CITY OF ALBUQUERQUE

Re: Hotel Chaco

Request 60-Day Temporary C.O. – Accepted Engineer's Stamp dated: 9/23/2016 (J13D066)

DRAINAGE PLAN AND

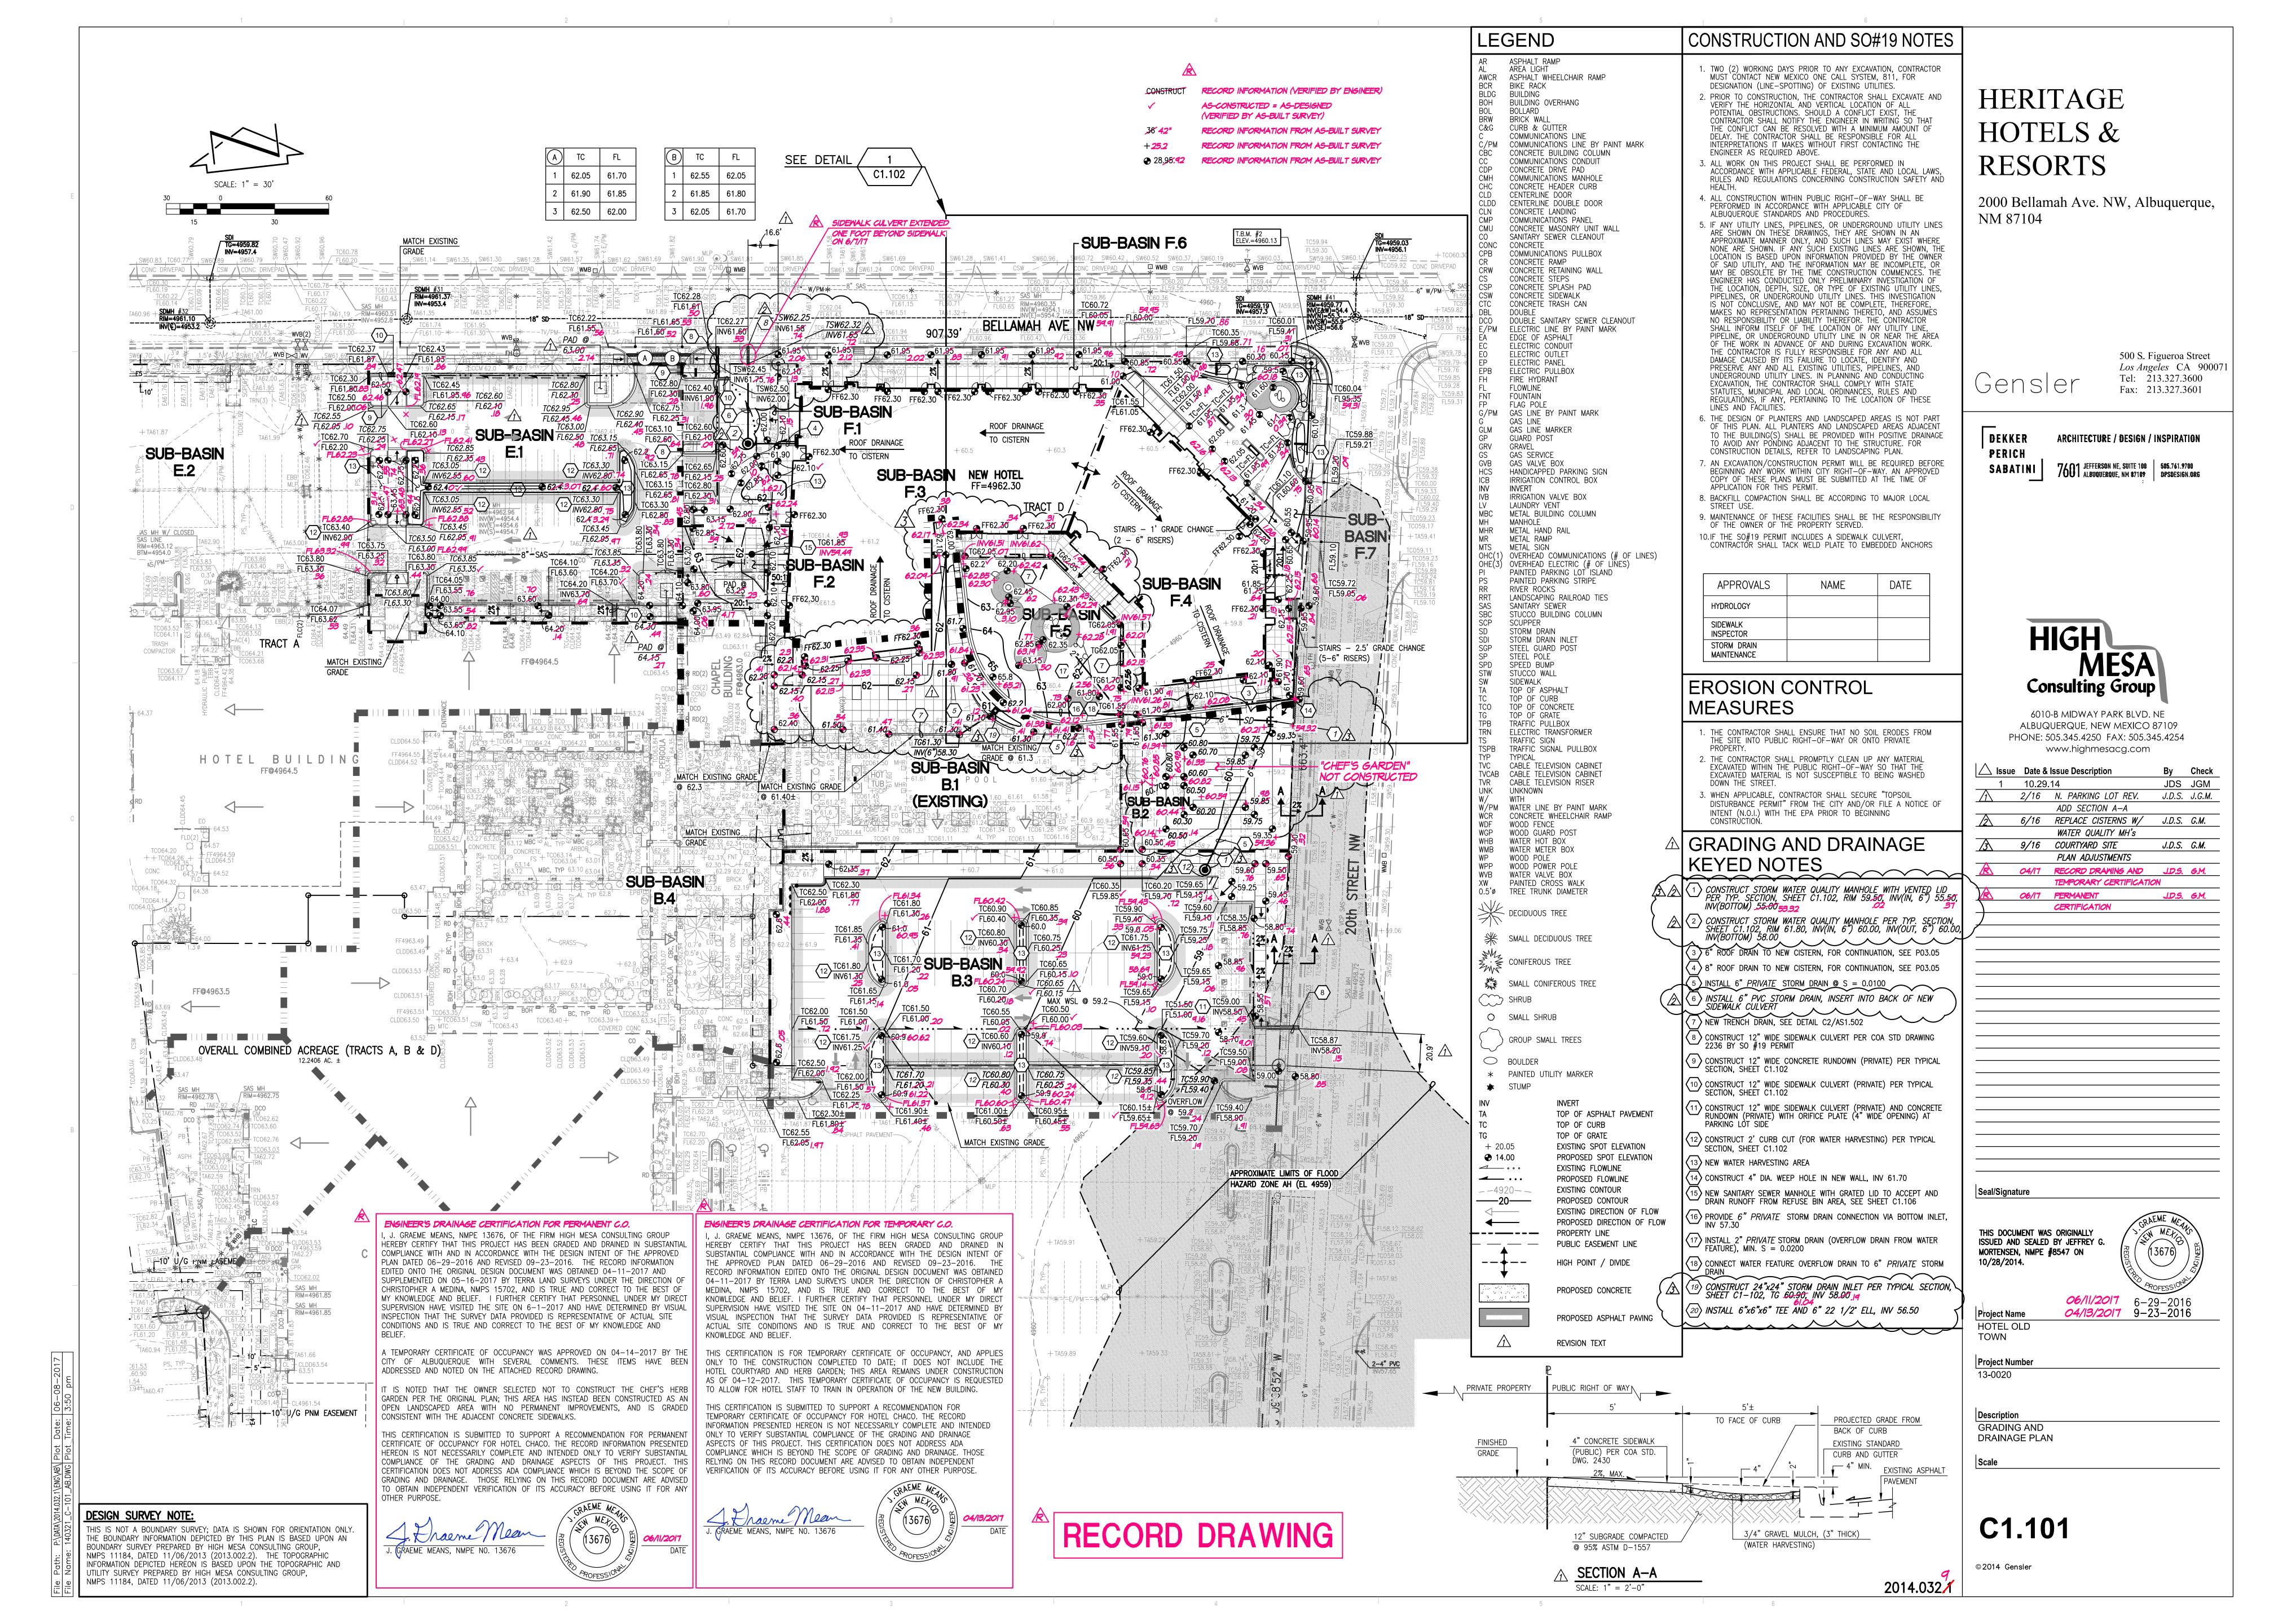
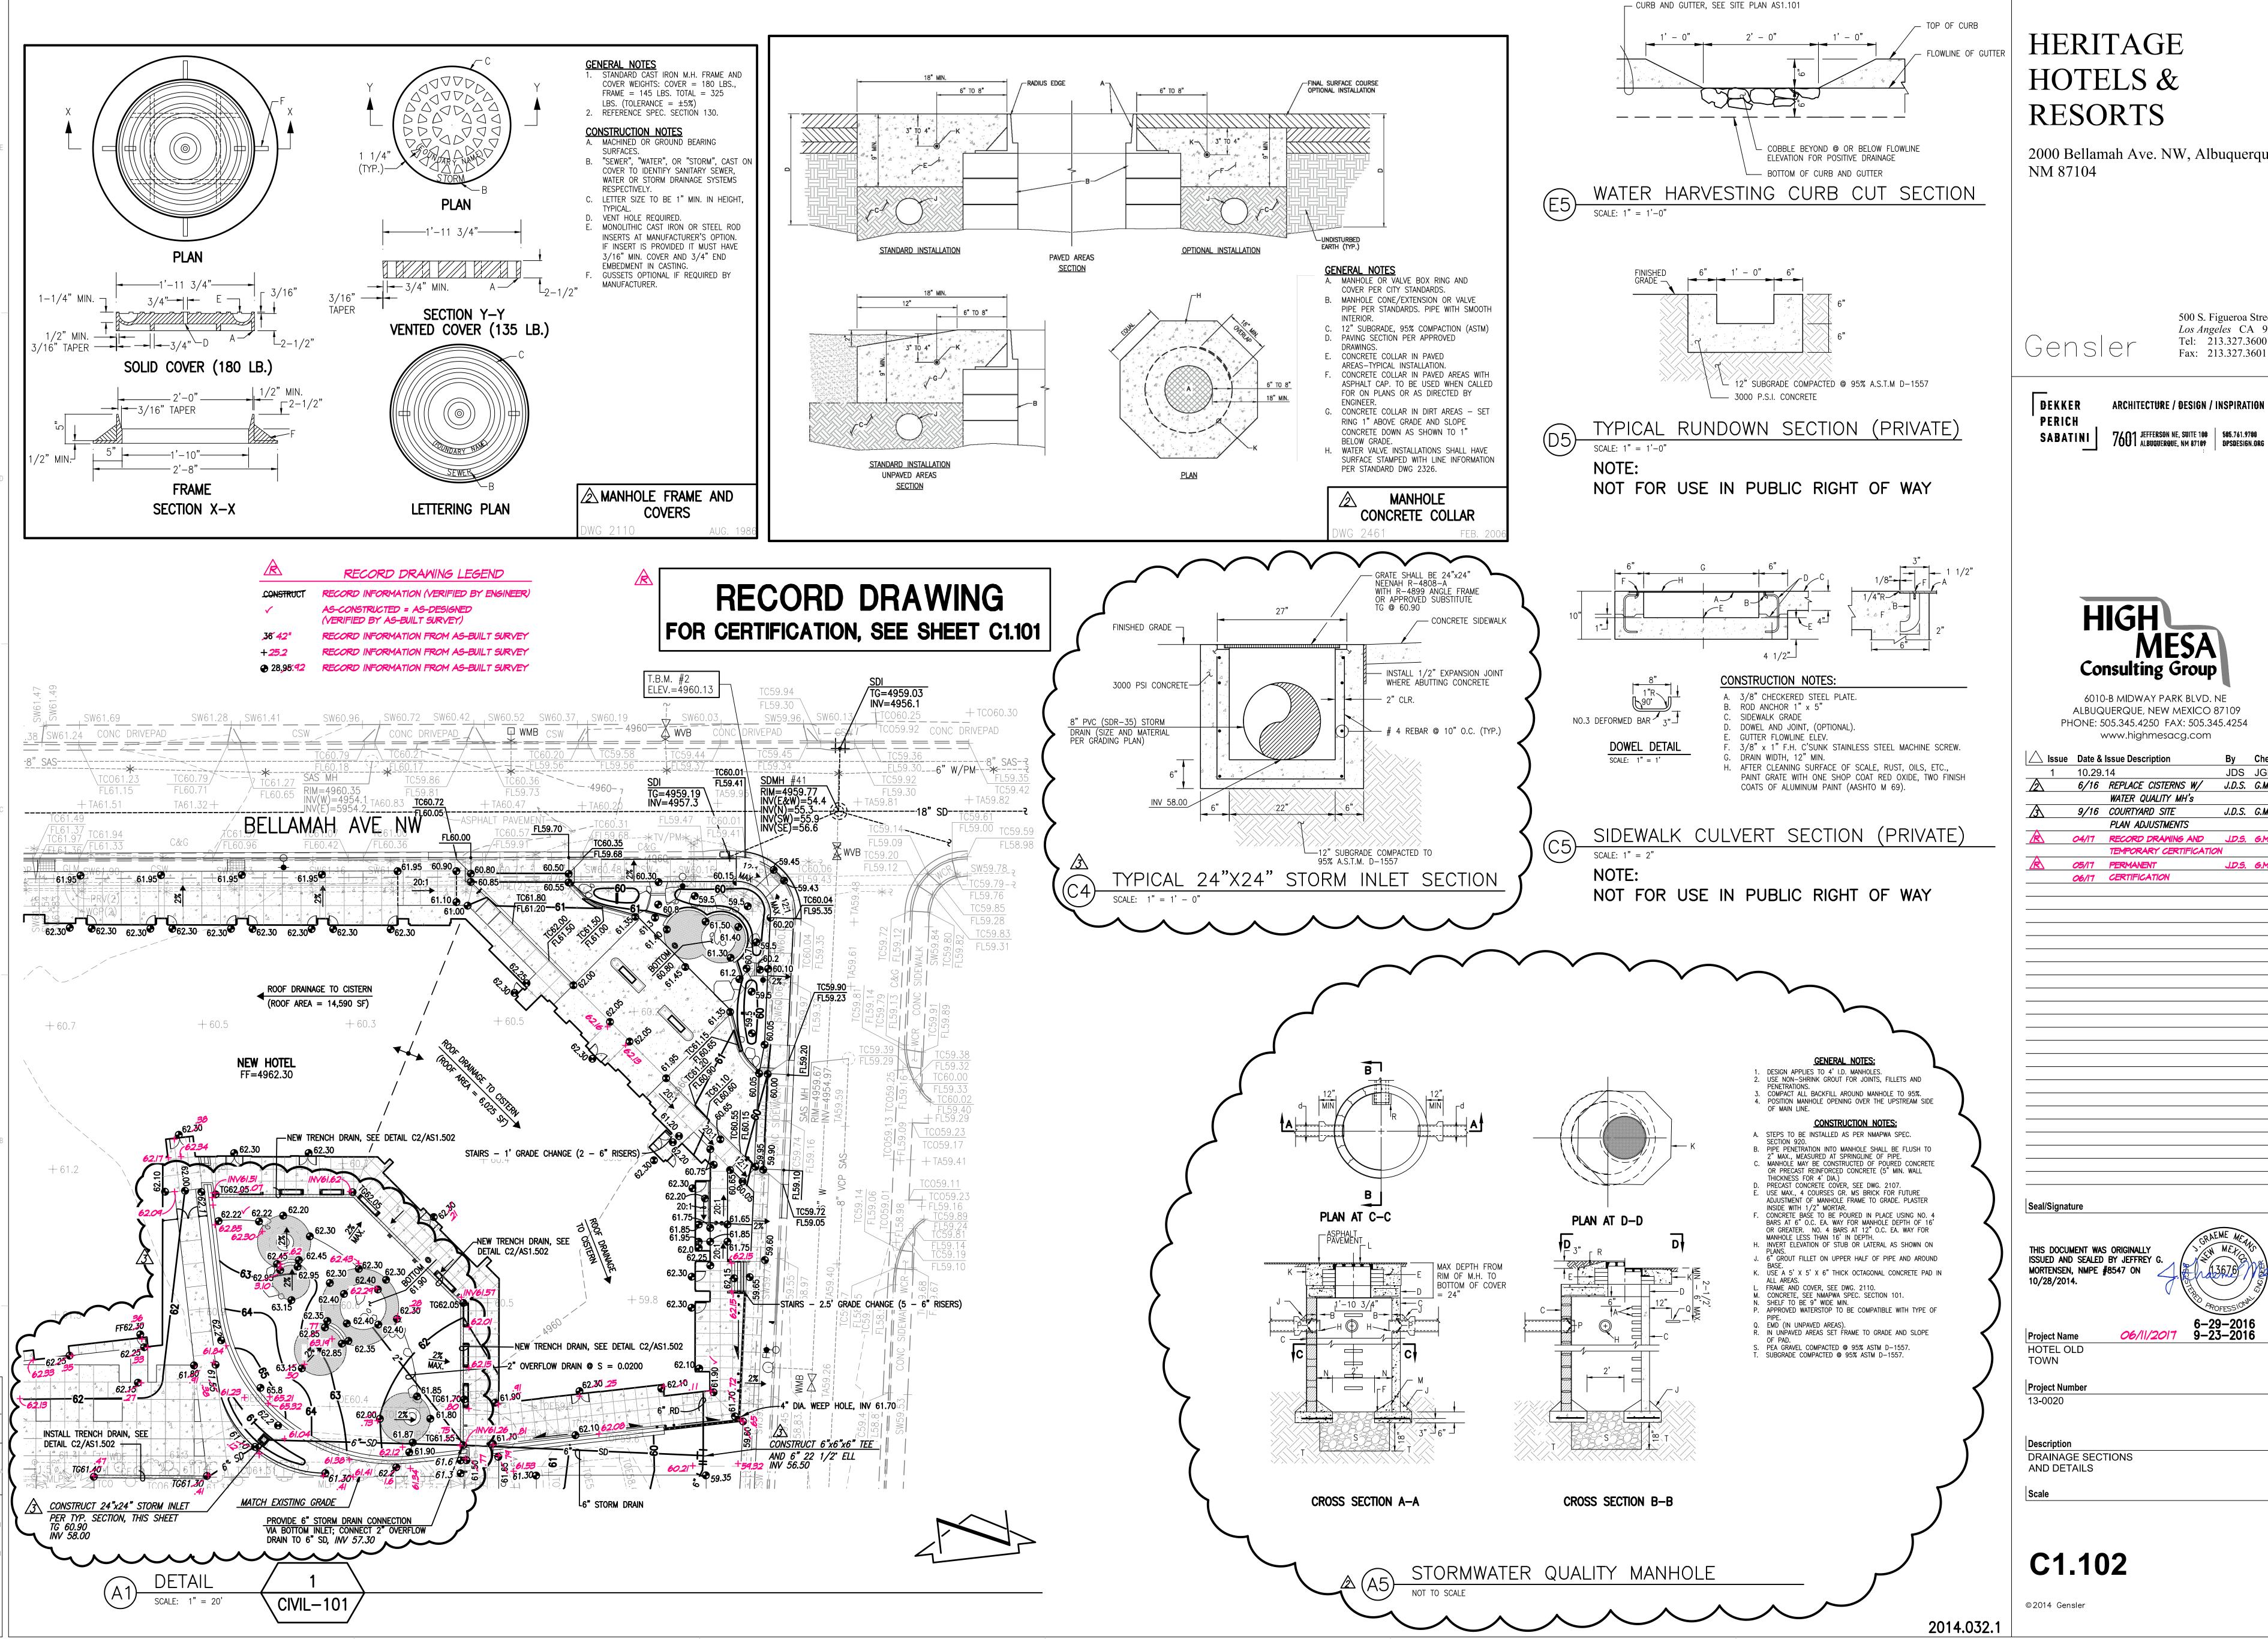
- Note #7 trench drains in courtyard are missing.
- As-built elevations indicate multiple inverts in the courtyard. Clarify inverts.
